Re: Building Permit no. 2020-3348

Here is a summary of the exterior changes that you can also review on the attached revised plans.

# **ADDITION & ALTERATIONS** FOR: PRISCILLA & RODRIGO VASCONCELLOS 9 WHIPPOORWILL LN, ARMONK, NY 10504 ZONE: R-2A SECTION:107.04 BLOCK: 1 LOT: 6

2	EXTERIOR WEST ELEVATION
A-201	SCALE: 1/4" = 1'-0"

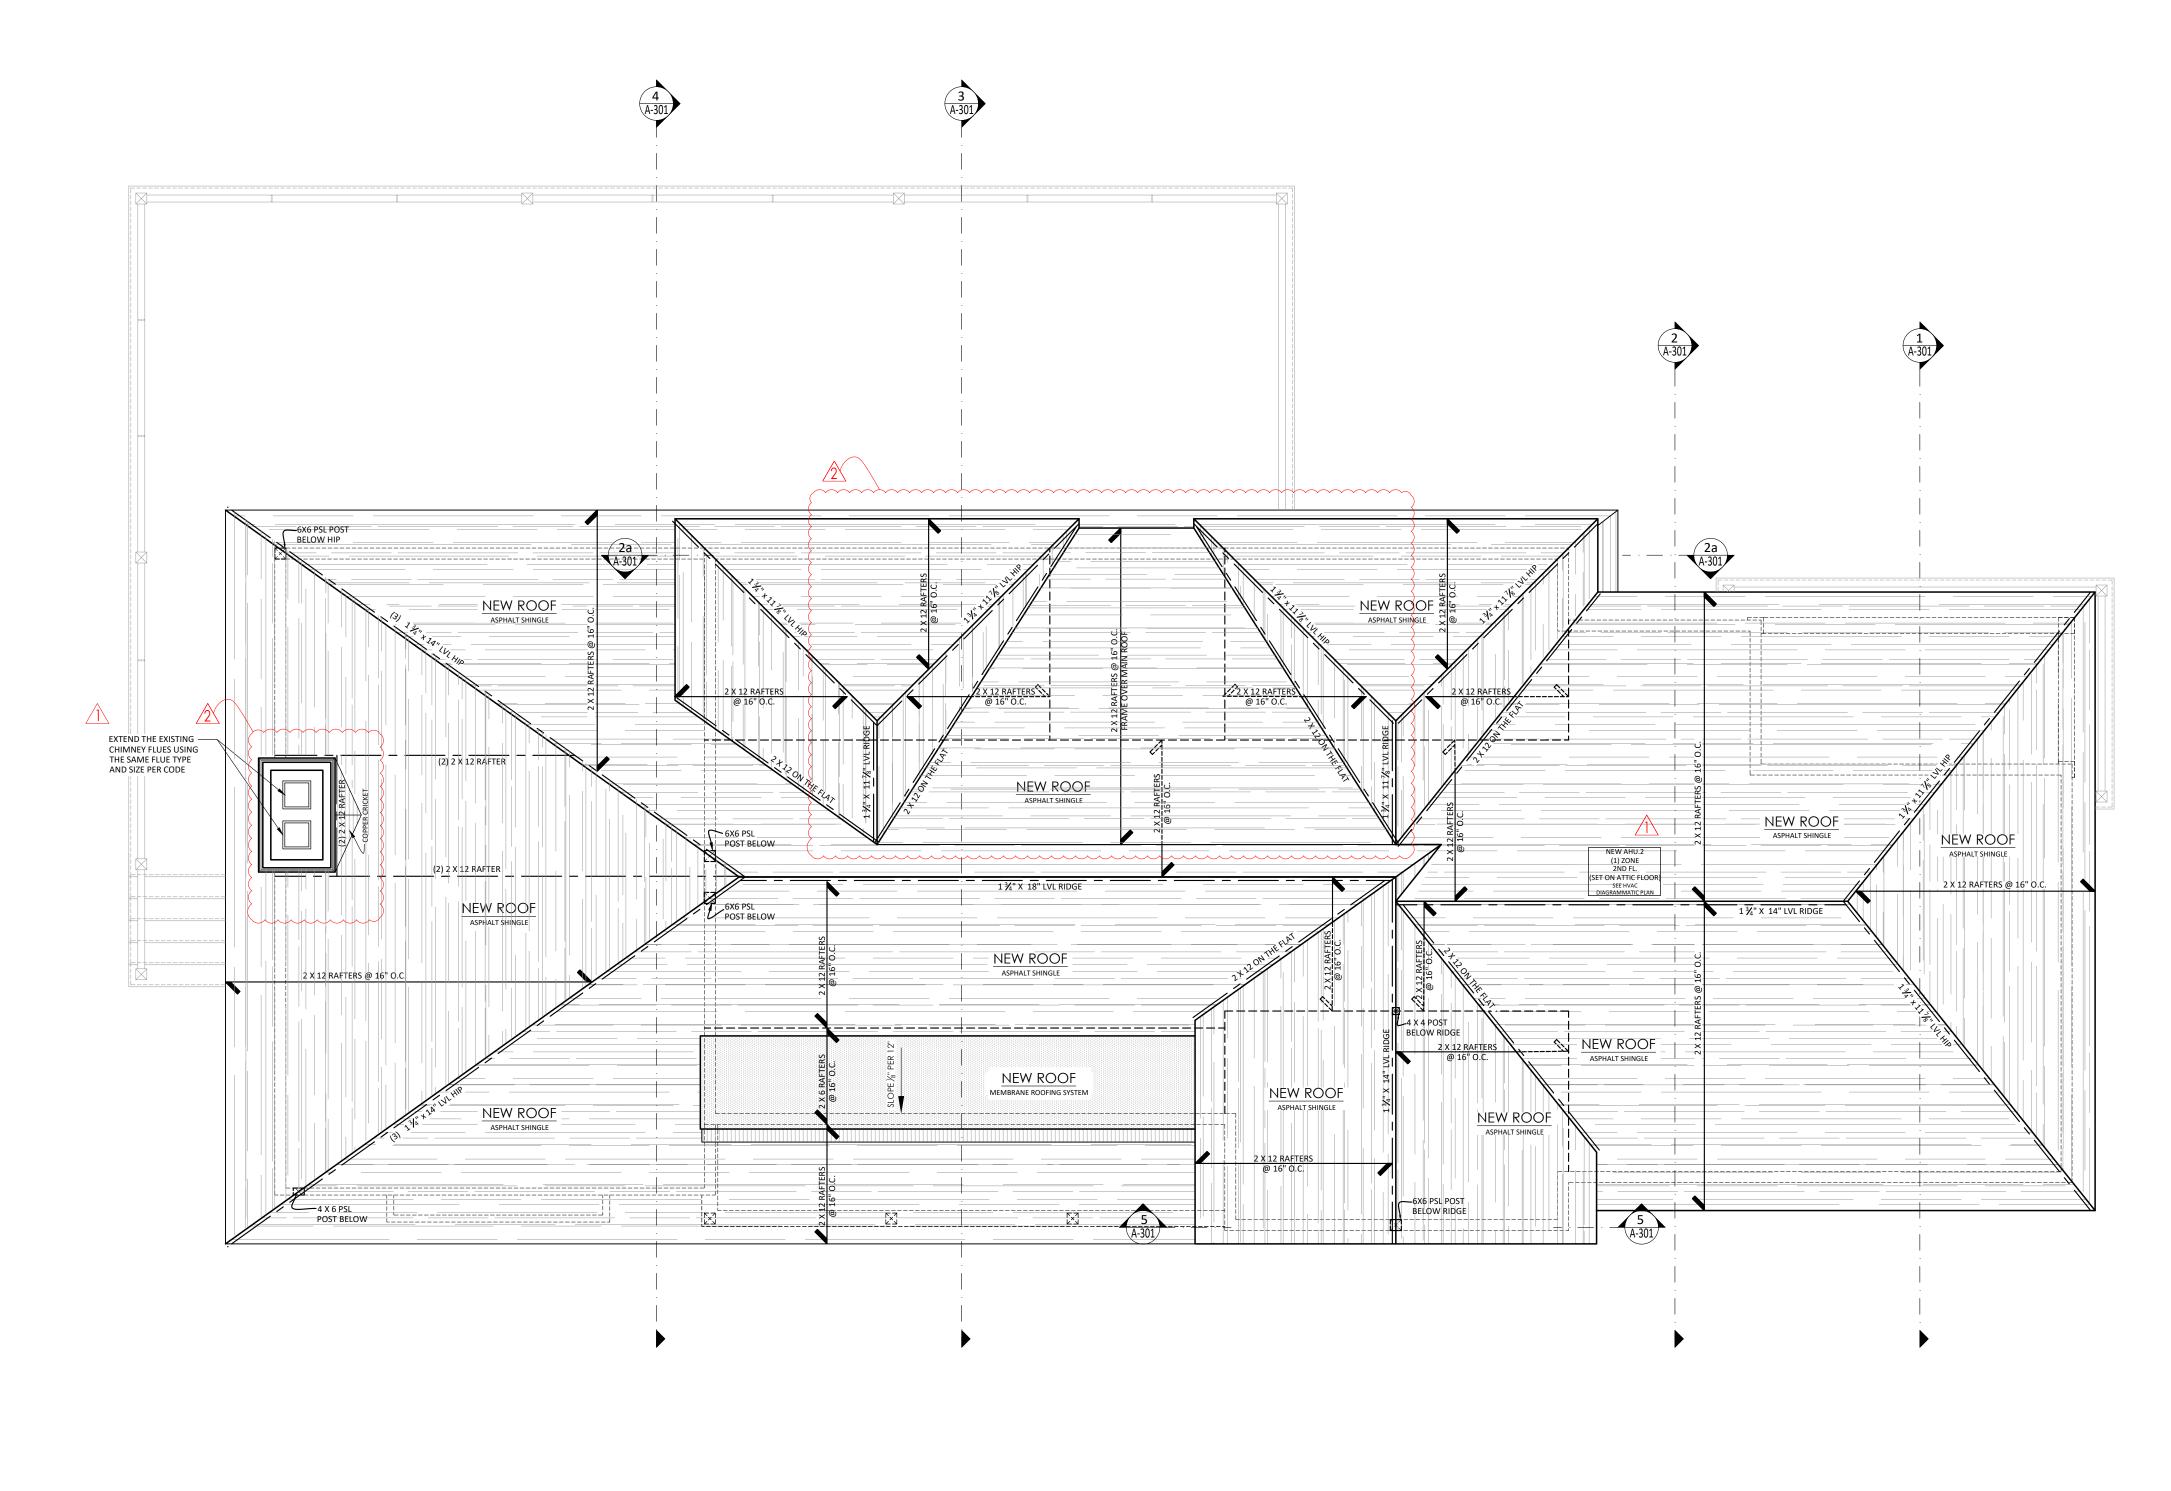
- Chimney design was changed to maintain original straight design. See detail 2 A-202
- Side Deck was shortened by approx. 200 SF. See detail 2 A-202
- Exterior door to side deck was replace to a window since the deck was shortened. See detail 2 A-202
- Basement exterior door & Master Balcony exterior door was change from a double slider to a single slider. See Exterior West Elevation.
